ENGINEERING ORDER

EO. No: A320HC52-004/14 R0

SUBJECT: ATA 52 - DOORS - LH NOSE LANDING GEAR DOOR - EROSION - PERMANENT REPAIR

Customer Services	DOORS # LH AND RH NOSE LANDING GEAR DOORS - EROSION - REPAIR.	Dossier Reference : 80002665
		Creation date dossier : 16-AUG-2014

FIGURE 1 SHEET 1 OF 3

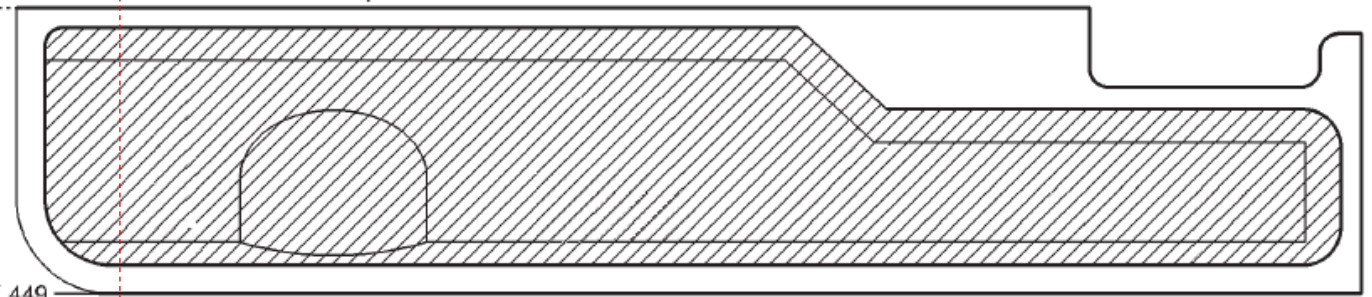
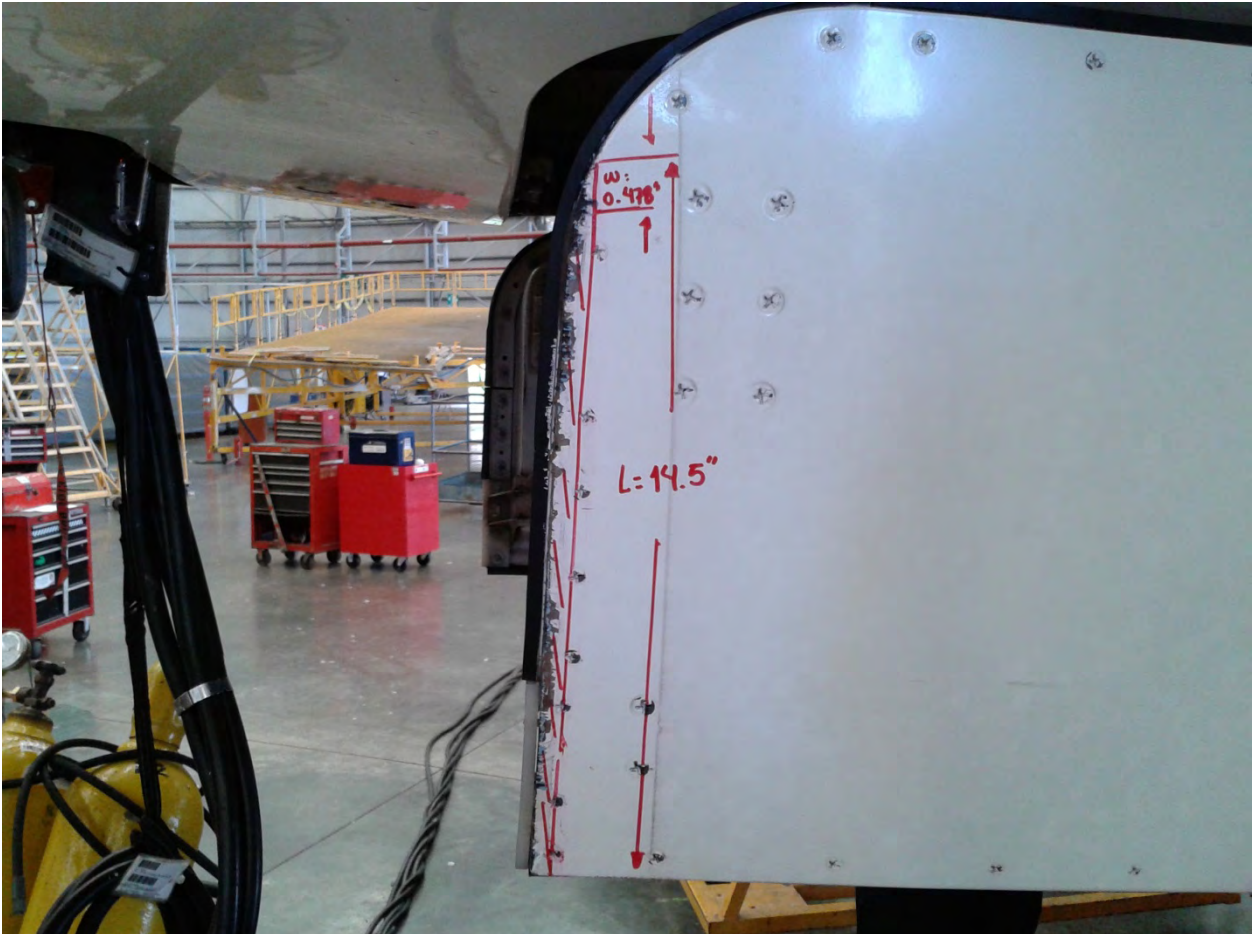
During major check at AEROMAN (SAL), LH and RH NLG doors of subject A/C were found with erosion damages on their fwd edges as shown in figure 1 of this report (Ref. /A/: AEM-14-04866/000). These damaged areas are out of repairable limits of A320 SRM 52-82-11.

REFER TO **DETAIL A** FOR
DAMAGED AREA LOCATION
AND DIMENSIONS ON LH
NLG DOOR PANEL.

**DETAIL A. ERODED AREA
LOCATION AND DIMENSIONS
ON LH NLG DOOR PANEL.**

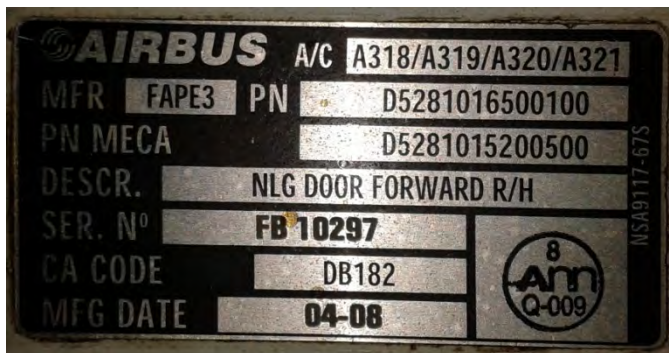
ERODED AREA:

Length = 14.5 inch.

Width = 0.478 inch.

Depth = 4 Plies.

No Skydrol Contamination

**DETAIL B. ERODED AREA
LOCATION AND DIMENSIONS
ON RH NLG DOOR PANEL.**

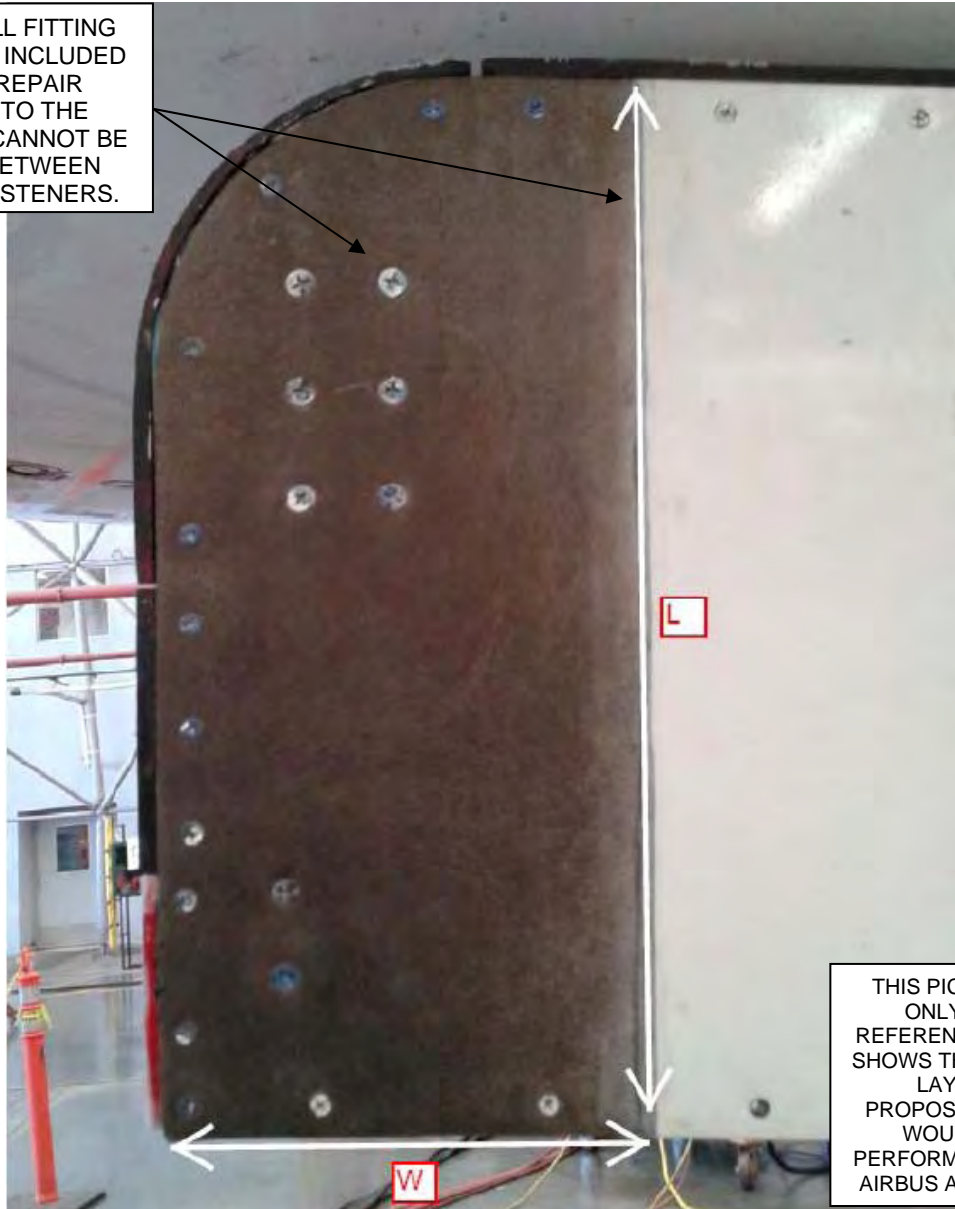
ERODED AREA:

Length = 14.25 inch.

Width = 0.386 inch.

Depth = 4 Plies.

No Skydrol Contamination
